SUBJECT: Final (100%) Remedial Design for LHAAP-47, Plant 3 Area, Solid Rocket Motor Fuel Production, Longhorn Army Ammunition Plant, Karnack, Texas

Comments Response Matrix
30% Remedial Design, LHAAP-47, Plant 3 Area, Solid Rocket Motor Fuel Production,
Longhorn Army Ammunition Plant, Karnack, Texas Submitted: May 14, 2025

Comments Response Matrix
60% Remedial Design, LHAAP-47, Plant 3 Area, Solid Rocket Motor Fuel Production,
Longhorn Army Ammunition Plant, Karnack, Texas Submitted: December 2, 2025

Comments Response Matrix
Draft 100% Remedial Design, LHAAP-47, Plant 3 Area, Solid Rocket Motor Fuel Production,
Longhorn Army Ammunition Plant, Karnack, Texas Submitted: April 21, 2026

FIGURE 6

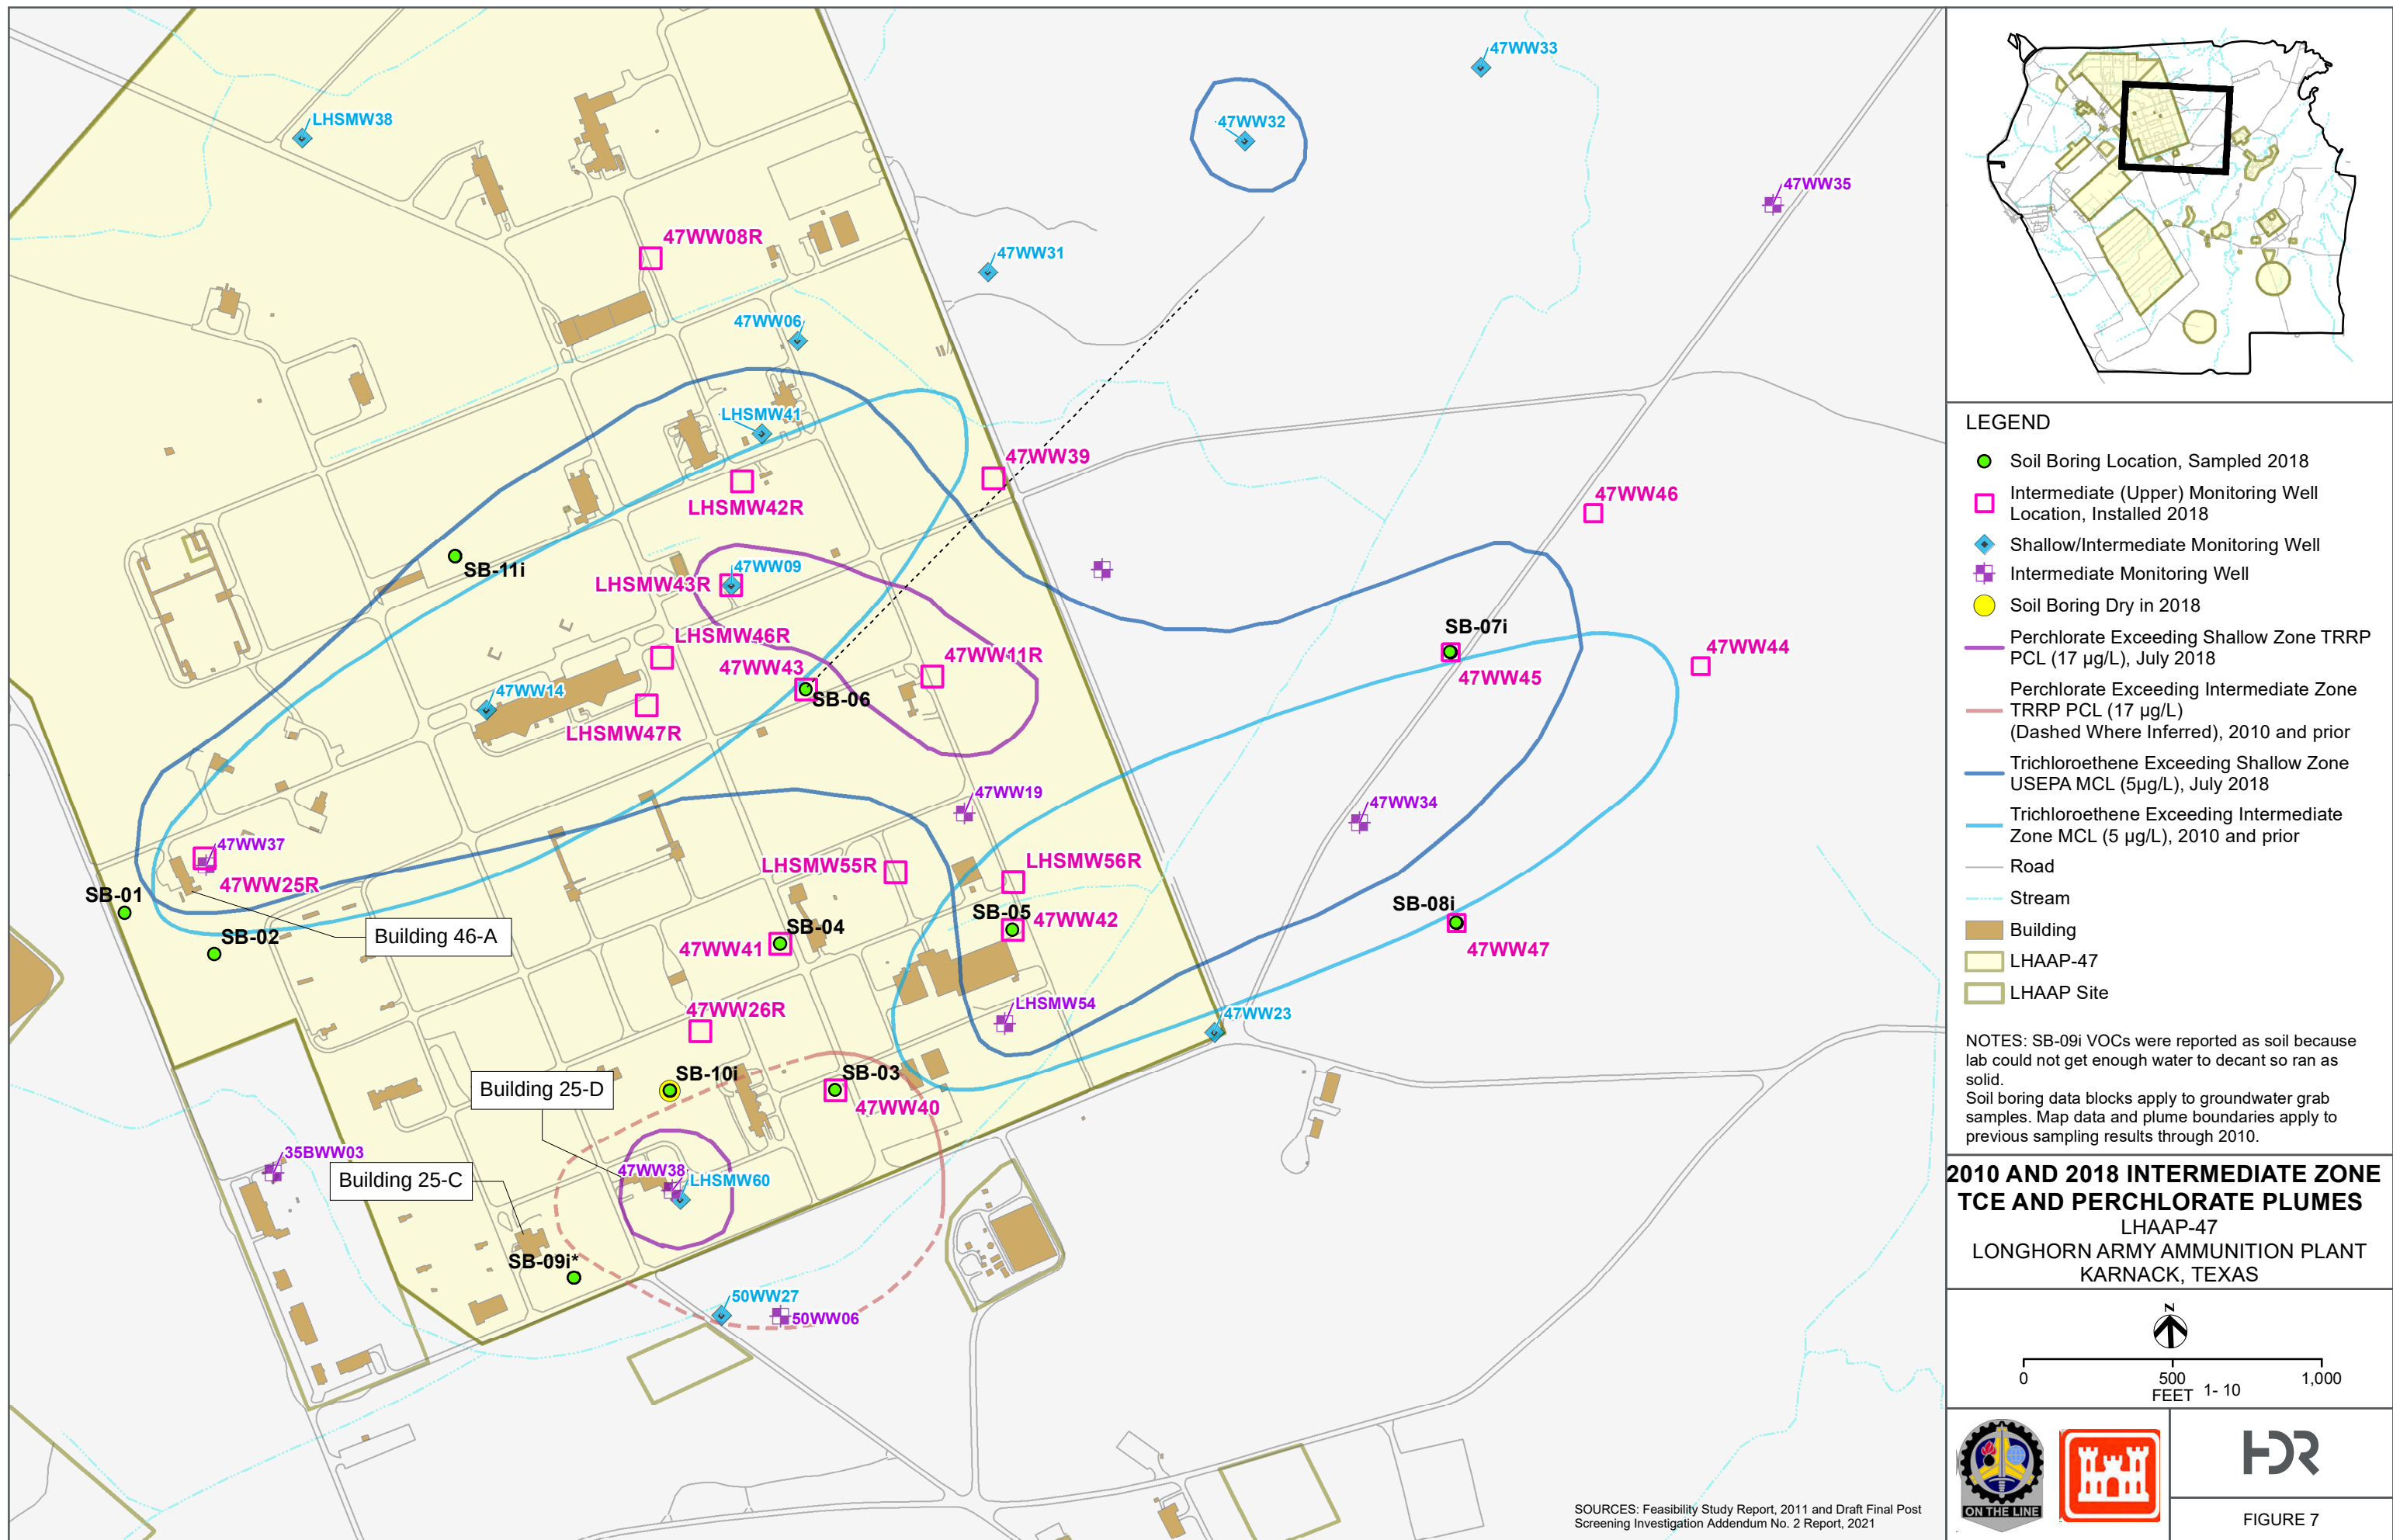
3	1.7.2/1-9	1/5-7	The statement is made that...”Perchlorate plumes are no longer present in the Shallow Zone, therefore, perchlorate plumes beyond year 2018 are not shown in PSI Figure 6 and PDI Figure 27 of Appendix C. ” even though the perchlorate plume in the Shallow Zone is shown in Figure 6.	D	Please note, the Figure 6 Legend states the perchlorate contours are for 2010 and prior.

FIGURE 19

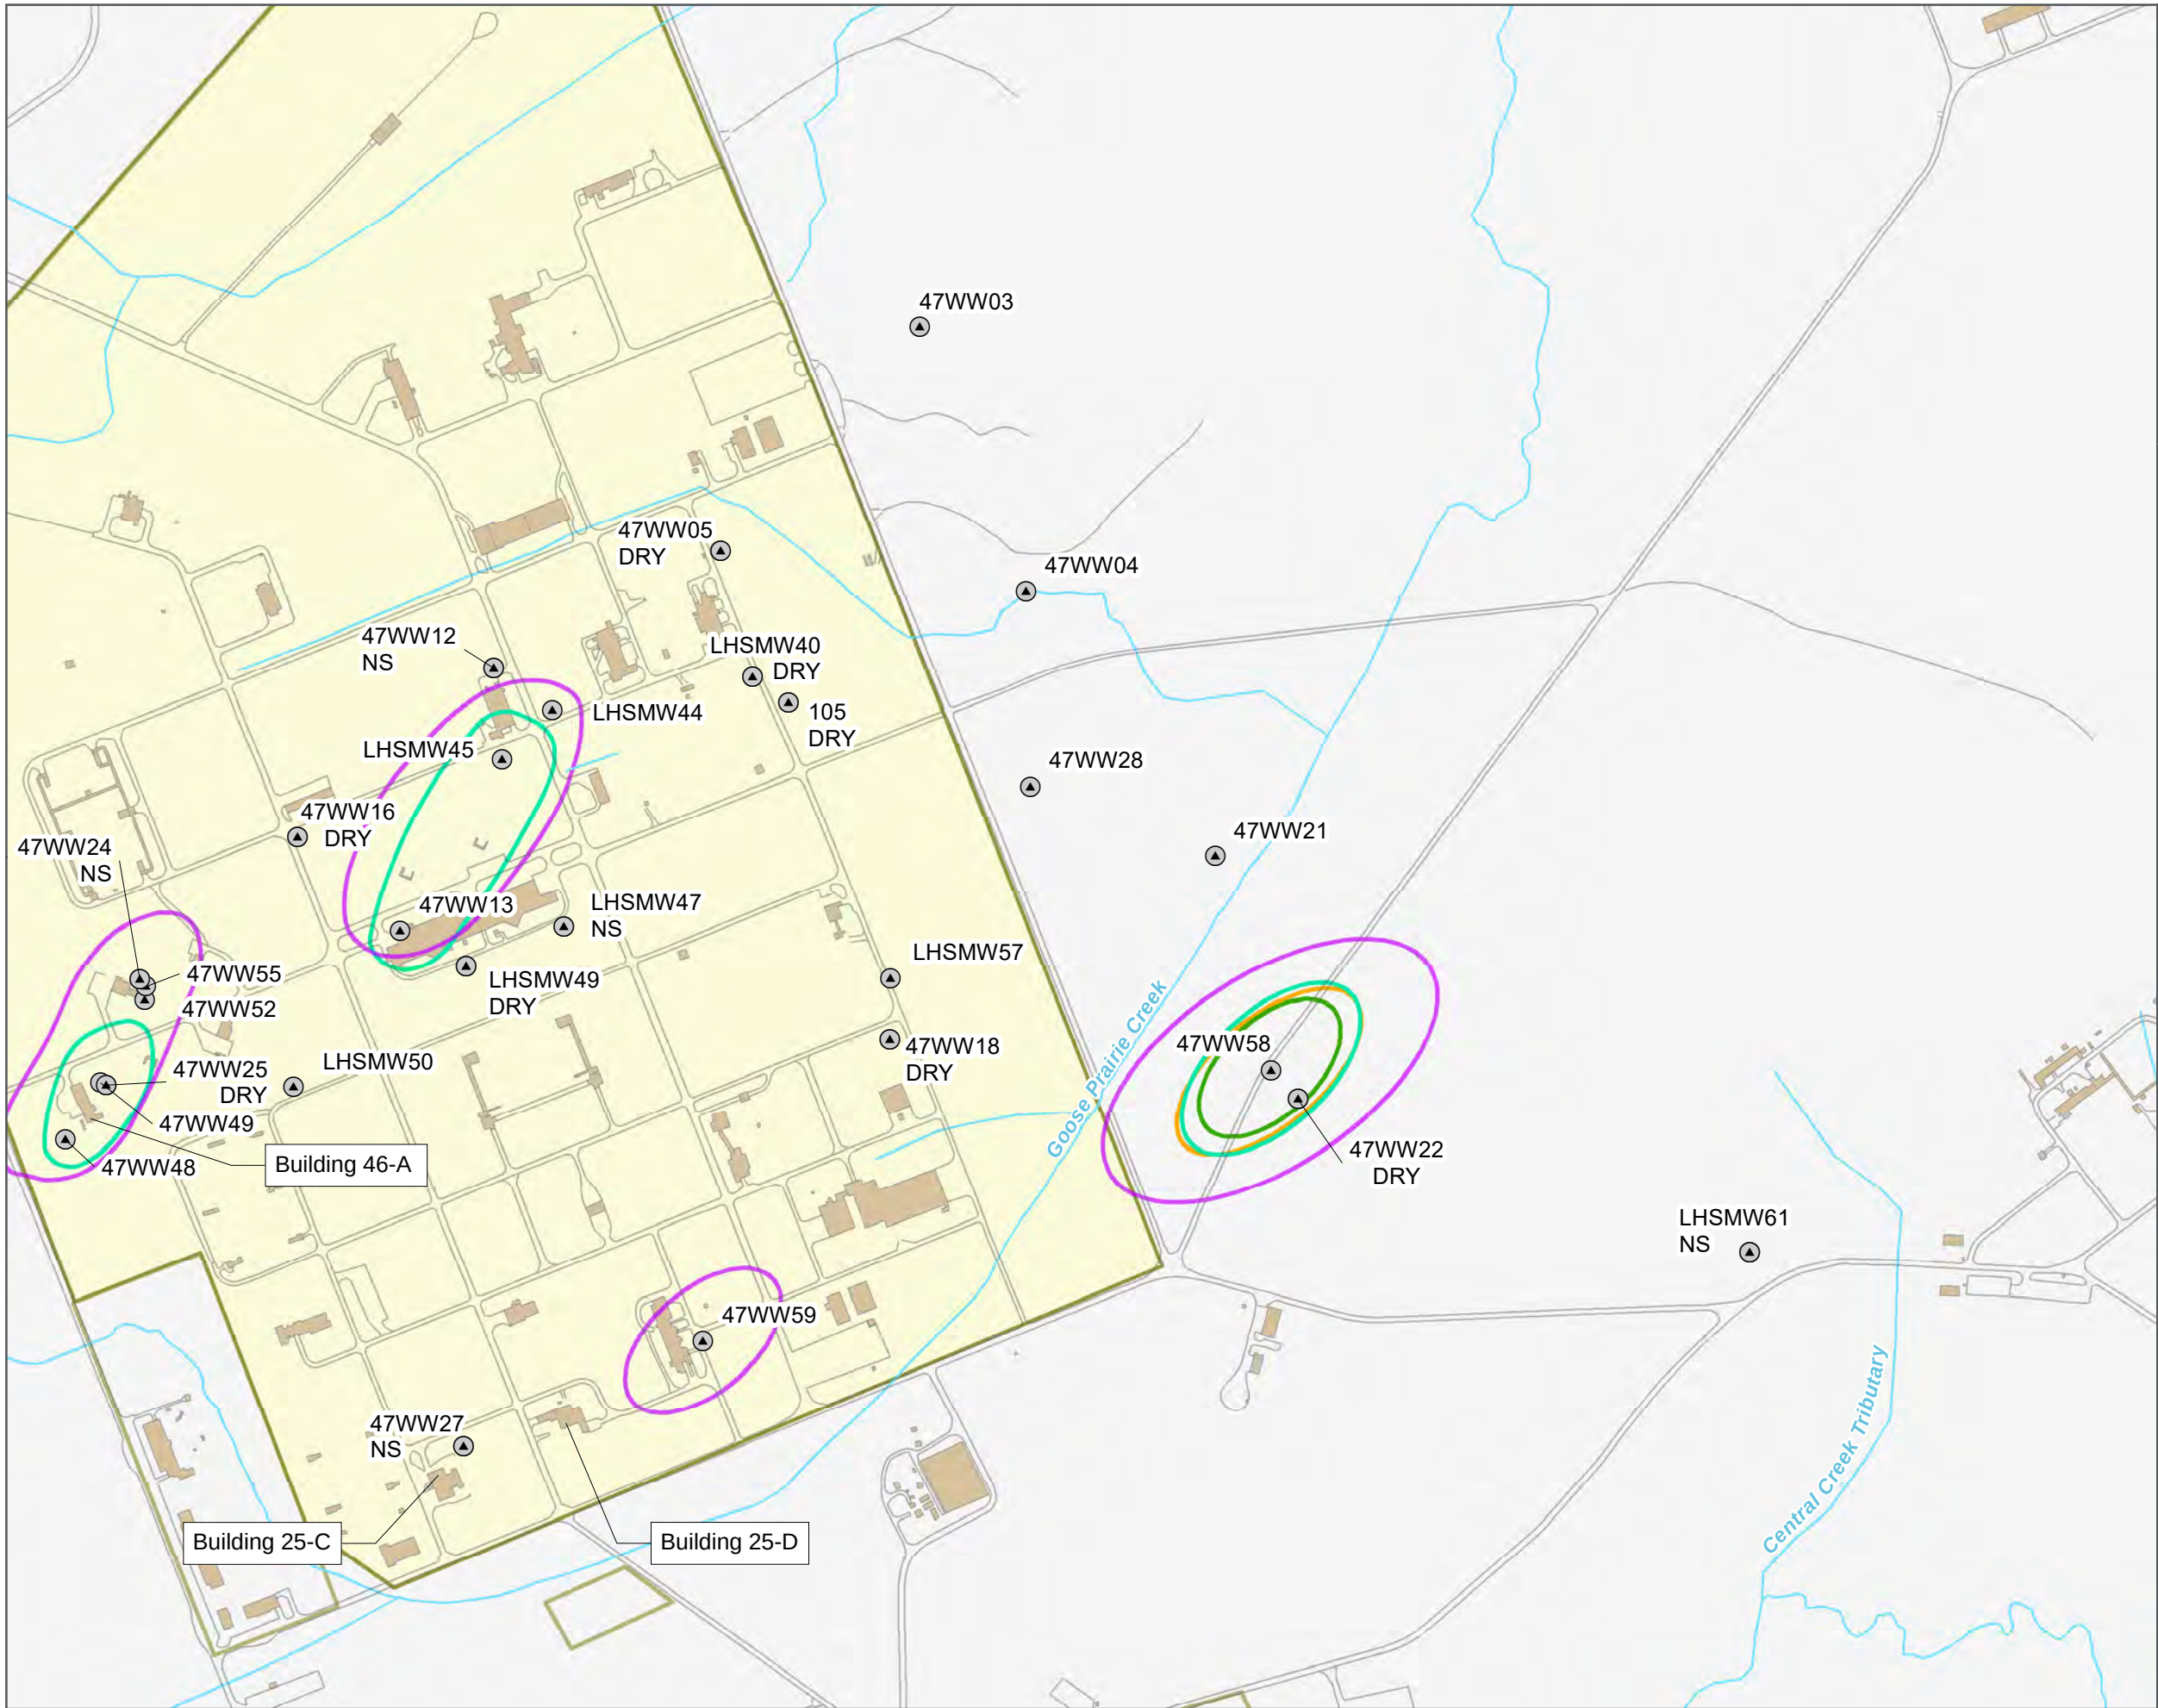
Number	Section/Page	Paragraph/Line	Comment	C,D	Response	A,D
13.	3.2/3-2	Area 4	PDI Figure 20 includes DPT results but does not include the results for 47WW25R. Is there another figure from the PDI that does include those results?	C	Figures provided in Appendix C have been incorporated as provided in previously approved reports. To remain consistent with the previously approved figure, changes are not recommended in that figure. However, in Draft (100%) Design Analysis Report, Section 3.2, The text was revised to reference the results for the 47WW25R: “Area 4, located in the Shallow/Intermediate Zone, is centered around abandoned well 47WW25R (PSI Figure 20 of Appendix C), which reported a maximum TCE concentration of 140,000 µg/L during the 2018 PSI (HDR, 2019a).”
